FIELD REPAIR / ALTERATION

CIRRUS DESIGN CORPORATION

AUTHOR:	SAMUEL L HORNE	CHANGE CLASS:	MINOR	REPAIR #	FRA00017030
Name:	FLOOR CRACK	REASONS AND REMARKS: DAMAGE TO RIGHT-HAND AFT FLOOR. REFERENCE FSR-822.		Models Affected	ASN# Impacted
Description:	RIGHT-HAND AFT FLOOR CRACK			SR22	1167
DOCUMENT TYPE:	FIELD REPAIR			n/a	
				n/a

FIGURE 1
AFT FLOOR DAMAGE REMOVAL AREA
NTS

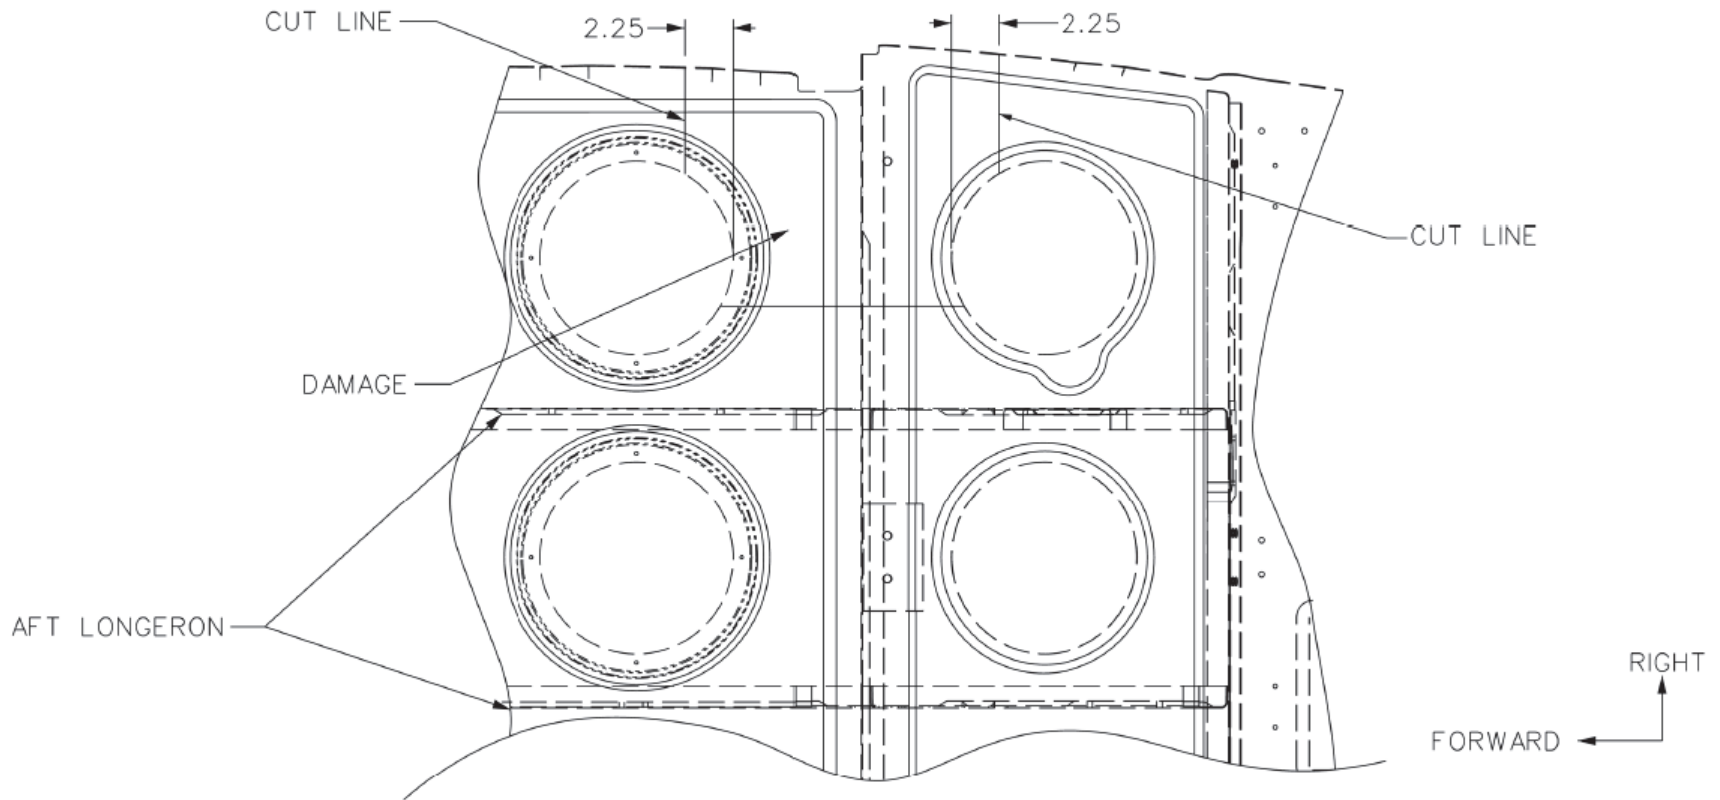
1. REMOVE ALL AFT ATTACH FITTINGS AND HARDWARE FROM DAMAGED SIDE OF AFT FLOOR.
2. REMOVE DAMAGED SECTION OF AFT FLOOR. REFER TO FIGURE 1.
 - A. CUT THROUGH FULL THICKNESS AFT FLOOR WHERE SHOWN IN FIGURE 1.

****NOTE: TAKE CARE NOT TO DAMAGE FUSELAGE SKIN DURING REMOVAL.****

FIGURE 2
 PRECURE BOND FLANGE INSTALLATION
 VIEW LOOKING DOWN ON INTERIOR AFT FLOOR
 NTS

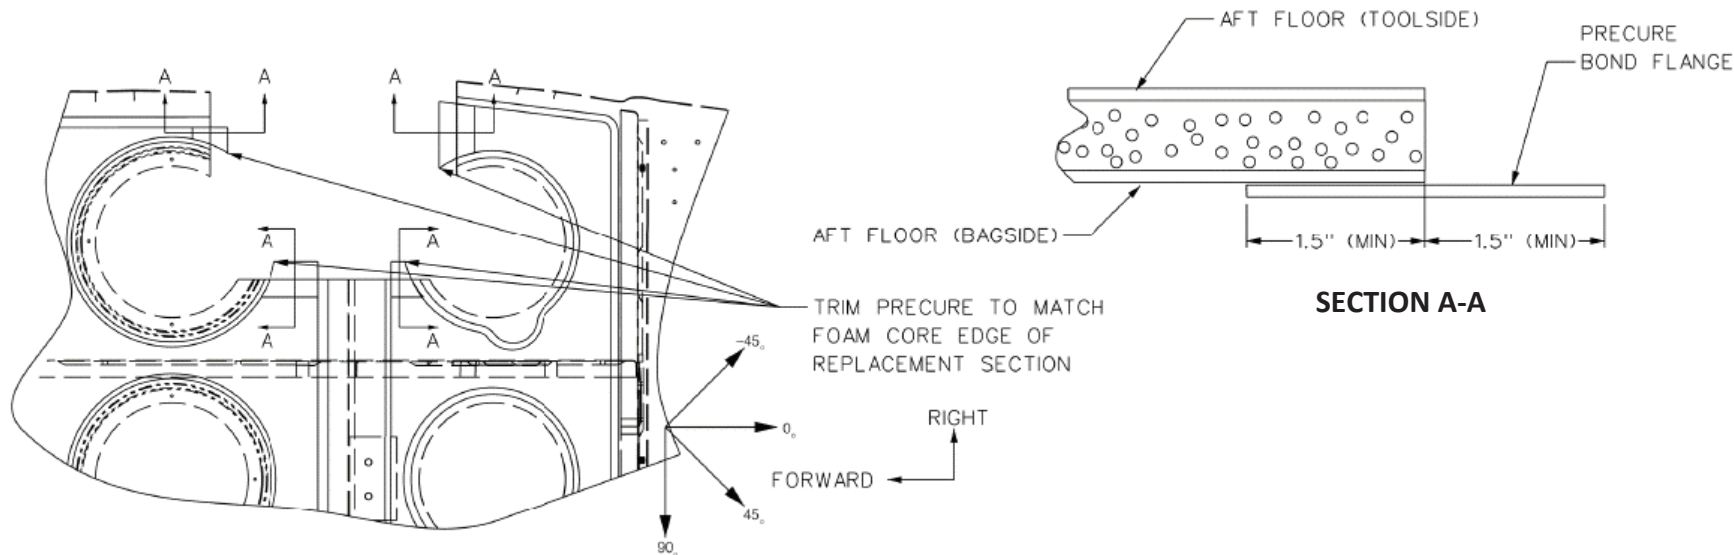
1. FABRICATE BOND FLANGES FOR AFT FLOOR REPAIR SECTION. REFER TO FIGURE 2.
 - A. USE 52005-003 TO FABRICATE FLANGES. ORIENT PRECURE 0° W.R.T ROSETTE IN FIGURE 2.
2. PREPARE FAYING SURFACES FOR BONDING PER AMM 51-20, "REPAIR SURFACE PREPARATION."
 - A. PREPARE THE FAYING SURFACES ON THE AFT FLOOR AND PRECURE BOND FLANGES.
 - B. PREPARE SURFACES BEYOND THE AREAS TO BE BONDED TO ENSURE PROPER ADHESION.
3. BOND PRECURE BOND FLANGES TO BAGSIDE SURFACE OF AFT FLOOR.
 - A. USE STRUCTURAL ADHESIVE PER AMM 51-30: PTM&W ES6292-A/B.
 - B. MIX ADHESIVE PER AMM 51-30, "STRUCTURAL REPAIR SYSTEM."
 - C. APPLY ADHESIVE PER AMM 51-30 "REPAIR PROCESSES."
 - D. ACHIEVE BOND THICKNESS OF 0.005" (MINIMUM) AND 0.060" (MAXIMUM).
 - E. SECURE PRECURE BOND FLANGES IN POSITION WITH FIXTURING AS REQUIRED TO PREVENT MOVEMENT DURING CURE.

****NOTE: MOVEMENT DURING CURE WILL CAUSE BOND VOIDS.****
4. CURE PRECURE FLANGE BONDS CURE PER AMM 51-20.

FIGURE 3
 REPAIR SECTION INSTALLATION
 VIEW LOOKING DOWN ON INTERIOR AFT FLOOR
 NTS

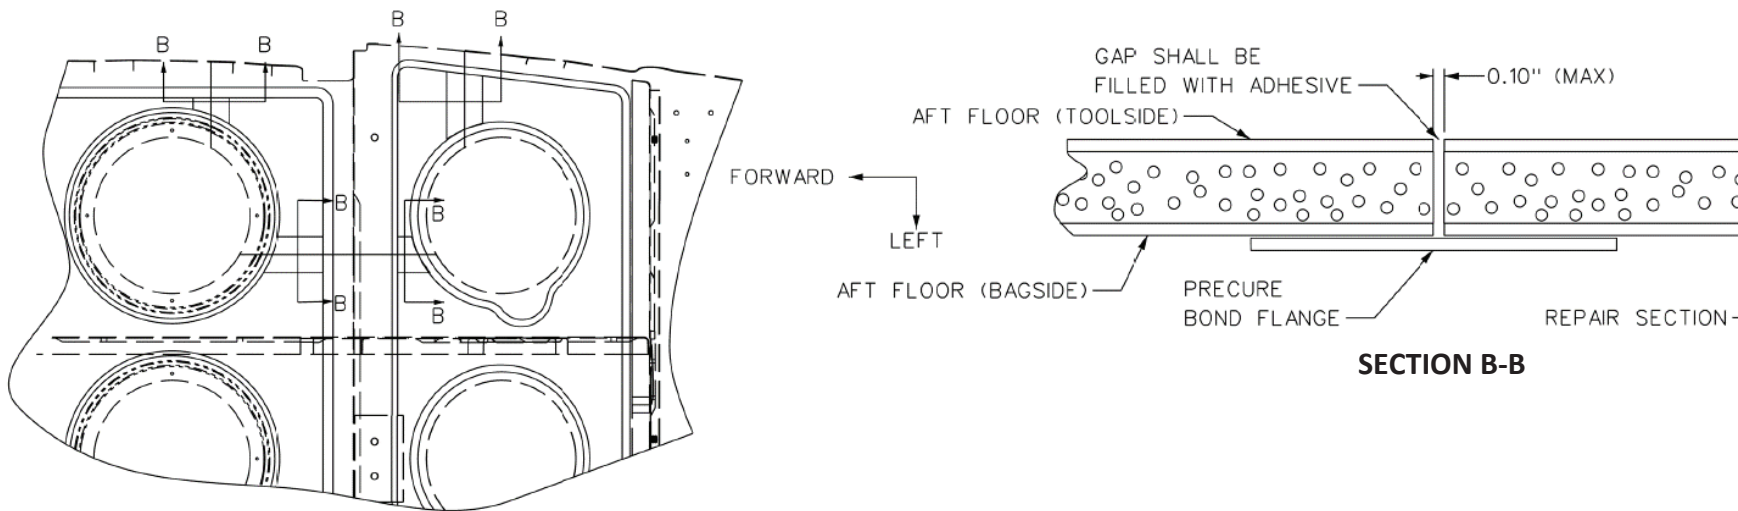
1. FIT REPAIR SECTION TO AFT FLOOR. REFER TO FIGURE 3.
 - A. TRIM AFT FLOOR REPAIR SECTION TO FIT INTO OPENING IN FIGURE 1.
 - B. SAND PERIMETER OF REPAIR SECTION AS REQUIRED TO FIT.

- C. MAXIMUM GAP OF 0.10" AROUND PERIMETER OF REPAIR SECTION IS PERMISSIBLE.
2. PERPREARE FAYING SURFACES FOR BONDING PER AMM 51-20, "REPAIR SURFACE PREPARATION."

- A. PREPARE THE FAYING SURFACES ON THE AFT FLOOR BOND FLANGES, FUSELAGE SKIN, AND REPAIR SECTION.
 - B. PREPARE AREAS SUFFICIENTLY BEYOND BOND AREA TO ENSURE PROPER ADHESION.

3. BOND REPAIR SECTION TO AFT FLOOR AND FUSELAGE SKIN.
 - A. USE STRUCTURAL ADHESIVE PER AMM 51-30: PTM&W ES6292-A/B.
 - B. MIX ADHESIVE PER AMM 51-30, "STRUCTURAL REPAIR SYSTEM."

- C. APPLY ADHESIVE PER AMM 51-30, "REPAIR PROCESSES."
 - D. ACHIEVE BOND THICKNESS OF 0.005" (MINIMUM) AND 0.080" (MAXIMUM).
 - E. SECURE REPAIR SECTION IN PLACE WITH FIXTURING AS REQUIRED TO PREVENT MOVEMENT DURING CURE.

****NOTE: MOVEMENT DURING CURE WILL CAUSE BOND VOIDS.****
4. CURE BOND PER AMM 51-20.

FIGURE 4
 AFT TOOLSIDE PRECURE PATCH
 VIEW LOOKING DOWN ON INTERIOR AFT FLOOR
 NTS

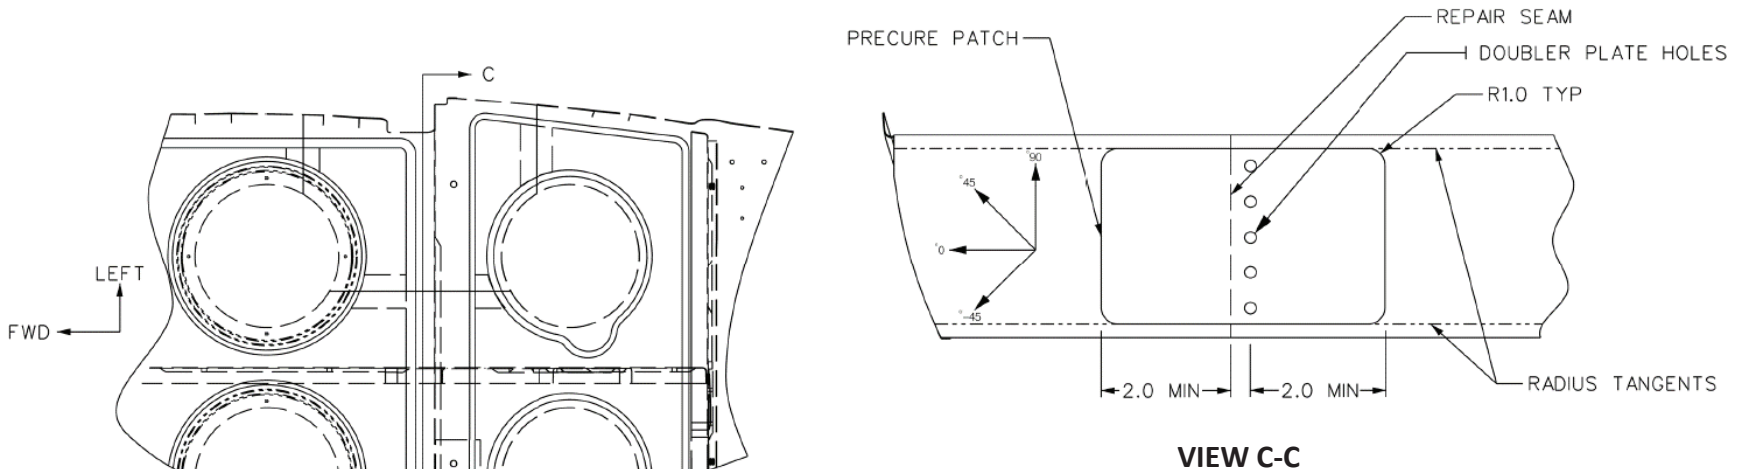
1. FABRICATE PRECURE REPAIR PATCH FOR AFT FLOOR TOOLSIDE SURFACE. REFER TO FIGURE 4.
 - A. USE 52005-003 TO FABRICATE PRECURE REPAIR PATCH. ALIGN 0° OF PRECURE PATCH W.R.T. ROSETTE IN FIGURE 4.

- B. OVERLAP REPAIR SECTION SEAM AND DOUBLER PLATE FASTENER HOLES IN INBOARD AND OUTBOARD DIRECTIONS BY 2.0" (MINIMUM), AND BUTT TO RADIUS TANGENTS IN UPPER AND LOWER DIRECTIONS.

2. PREPARE FAYING SURFACES FOR BONDING PER AMM 51-20, "REPAIR SURFACE PREPARATION."
 - A. PREPARE THE FAYING SURFACES ON THE AFT FLOOR TOOLSIDE SURFACE AND PRECURE PATCH.

- B. PREPARE SURFACE SUFFICIENTLY BEYOND THE BOND AREA TO ENSURE PROPER ADHESION.
3. BOND PRECURE PATCH TO AFT FLOOR TOOLSIDE SURFACE.
 - A. USE STRUCTURAL ADHESIVE PER AMM 51-30: PTM&W ES6292-A/B.

- B. MIX ADHESIVE PER AMM 51-30, "STRUCTURAL REPAIR SYSTEM."
 - C. APPLY ADHESIVE PER AMM 51-30 "REPAIR PROCESSES."
 - D. ACHIEVE BOND THICKNESS OF 0.005" (MINIMUM) TO 0.060" (MAXIMUM).

- E. SECURE PRECURE PATCH IN POSITION AS REQUIRED TO PREVENT MOVEMENT DURING CURE.

****NOTE: MOVEMENT DURING CURE WILL CAUSE BOND VOIDS.****
4. CURE BOND PER AMM 51-20.

FIGURE 5

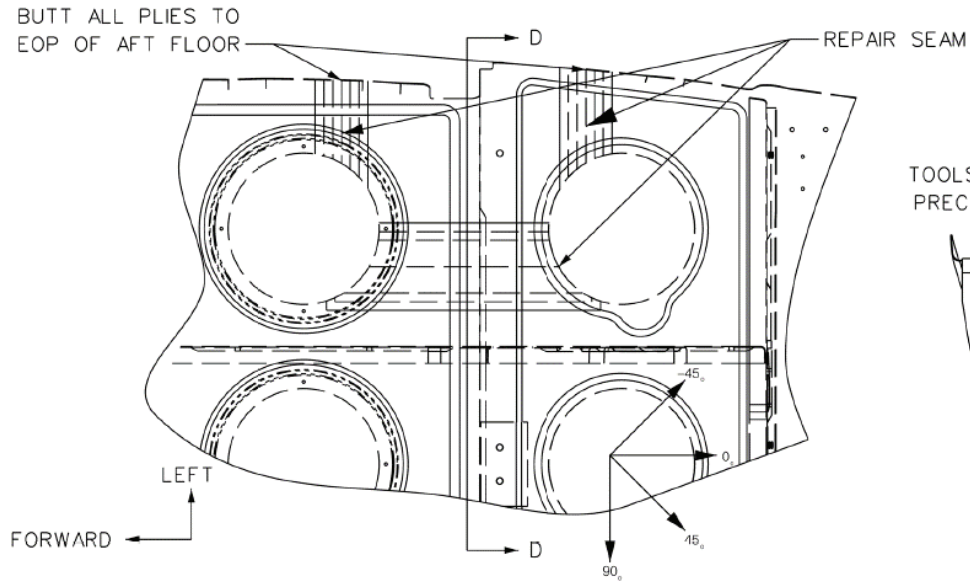
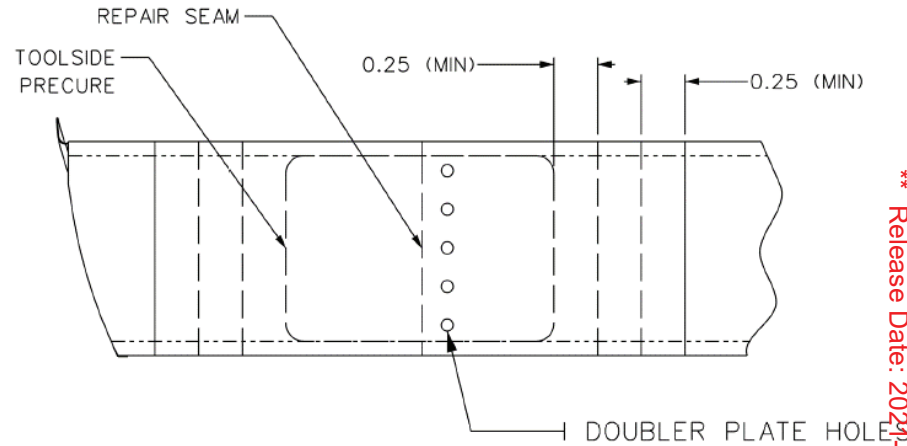
1. FABRICATE THREE (3) REPAIR PLYS FOR THE AFT FLOOR TOOLSIDE SURFACE. REFER TO FIGURE 5.
 - A. USE STRUCTURAL FABRIC PER AMM 51-30: HEXCEL 7781/F16.
 - B. ORIENT REPAIR PLYS AS FOLLOWS (IN ORDER OF PLY APPLICATION): +45°/ 0°/-45° W.R.T. ROSETTE IN FIGURE 5.

- C. FOR FIRST PLY, MAINTAIN 0.25" (MINIMUM) OVERLAP BEYOND PRECURE PATCH AND REPAIR SECTION SEAMS IN ALL DIRECTIONS UNLESS NOTED OTHERWISE.
 - i. BUTT PLY TO ACCESS PANEL(S).

- D. FOR SUBSEQUENT PLYS, MAINTAIN 0.25" (MINIMUM) OVERLAP BEYOND PRECEDING PLYS IN ALL DIRECTIONS UNLESS NOTED OTHERWISE.
 - i. BUTT PLYS TO ACCESS PANEL(S).

2. PREPARE THE AREA FOR WET-LAY PER AMM 51-20, "REPAIR SURFACE PREPARATION."
 - A. PREPARE SURFACES SUFFICIENTLY BEYOND THE AREA OF THE LARGEST REPAIR PLY TO ENSURE PROPER ADHESION.

3. WET-LAY REPAIR PLYS ONTO AFT FLOOR TOOLSIDE SURFACE.
 - A. USE STRUCTURAL RESIN SYSTEM PER AMM 51-30: L285/H287.
4. CURE WET-LAY PER AMM 51-20.

1. FABRICATE THREE (3) REPAIR PLYS FOR THE AFT FLOOR BAGSIDE SURFACE. REFER TO FIGURE 5.
 - A. USE STRUCTURAL FABRIC PER AMM 51-30: HEXCEL 7781/F16.
 - B. ORIENT REPAIR PLYS AS FOLLOWS (IN ORDER OF PLY APPLICATION): +45°/ 0°/-45° W.R.T. ROSETTE IN FIGURE 5.

- C. FOR FIRST PLY, MAINTAIN 0.25" (MINIMUM) OVERLAP BEYOND PRECURE PATCH, REPAIR SEAMS, AND DOUBLER PLATE FASTENER HOLES IN ALL DIRECTIONS UNLESS NOTED OTHERWISE.

- i. BUTT PLY TO ACCESS PANEL(S).
 - D. FOR SUBSEQUENT PLYS, MAINTAIN 0.25" (MINIMUM) OVERLAP BEYOND PRECEDING PLYS IN ALL DIRECTIONS UNLESS NOTED OTHERWISE.

- i. BUTT PLYS TO ACCESS PANEL(S).
2. PREPARE THE AREA FOR WET-LAY PER AMM 51-20, "REPAIR SURFACE PREPARATION."
 - A. PREPARE SURFACES SUFFICIENTLY BEYOND THE AREA OF THE LARGEST REPAIR PLY TO ENSURE PROPER ADHESION.

3. FILL REMAINING HOLES FROM TEMPORARY REPAIR DOUBLER WITH FILLER PASTE.
 - A. MIX AND APPLY FILLER PASTE PER AMM 51-20, "FILLER PASTE APPLICATION."
 - i. USE STRUCTURAL RESIN SYSTEM PER AMM 51-30: L285/H287.

- B. INITIAL CURE FILLER PASTE PER AMM 51-20.
4. WET-LAY REPAIR PLYS ONTO AFT FLOOR BAGSIDE SURFACE.
 - A. USE STRUCTURAL RESIN SYSTEM PER AMM 51-30: L285/H287.

5. CURE WET-LAY PER AMM 51-20.
